Our Case Number: ABP-314724-22

Re: Railway (Metrolink - Estuary to Charlemont via Dublin Airport) Order [2022]
Metrolink. Estuary through Swords, Dublin Airport, Ballymun, Glasnevin and City Centre to
Charlemont, Co. Dublin

Re: Railway (Metrolink-Estuary to Charlemont via Dublin Airport) Order 2022

Formal submission

Excerpt from Drawing no. ML1-JAI-ARD-ROUT_XX-DR-Y-03095 indicating the extent of the Metro tunnel relative to our clients' property at no. 9 Harcourt Terrace

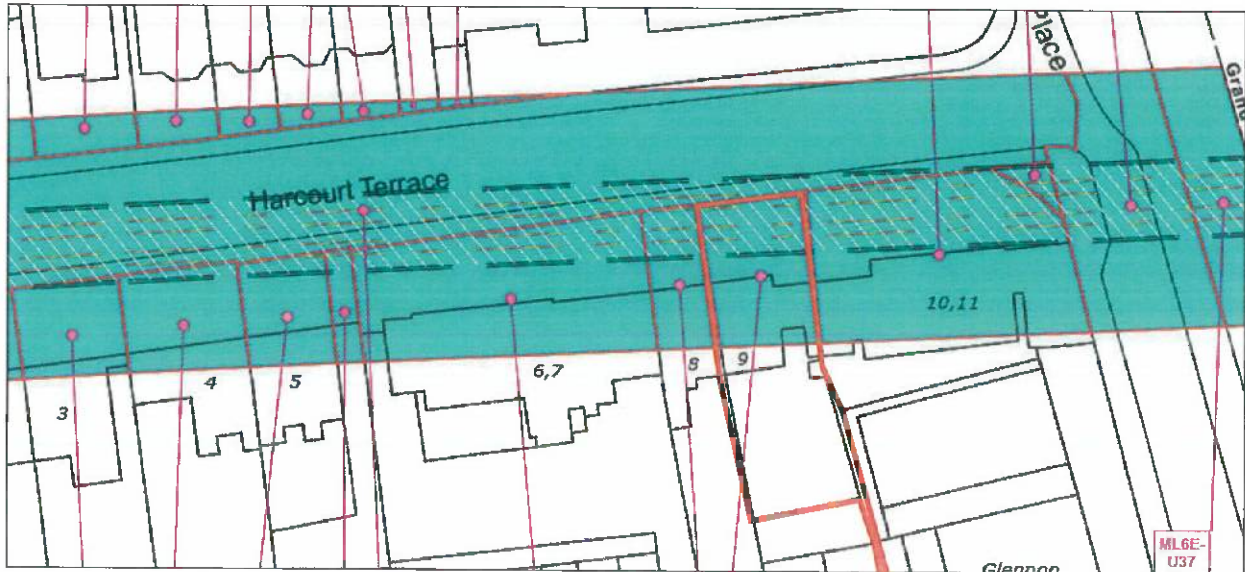
We note that the Metro tunnel alignment drawings (Drawing no. ML1-JAI-ARD-ROUT_XX-DR-Y-03095) (Plan Drawing no. ML-RO 306 E-O) indicate the extent of the Metro tunnel as passing under the front curtilage and entrance steps to our clients' property. Their property is located between the St. Stephens Green and Charlemont stations on the route.

The cross-section AA on this same drawing, which is located at the footpath along the northern side of the Grand Canal, indicates the top of the Proposed Metro tunnel as being c. 18m below ground level. We note that the nearest cross section to this to the north, at Earlsfort Terrace, on Drawing no. ML1-JAI-ARD-ROUT_XX-DR-Y-03094 (Plan Drawing no. ML-RO 306 D-E) also indicates the top of the Proposed Metro tunnel as being c. 18m below ground level. It is reasonable therefore to conclude that the top of the tunnel will pass c. 18m below the front of our clients' property.
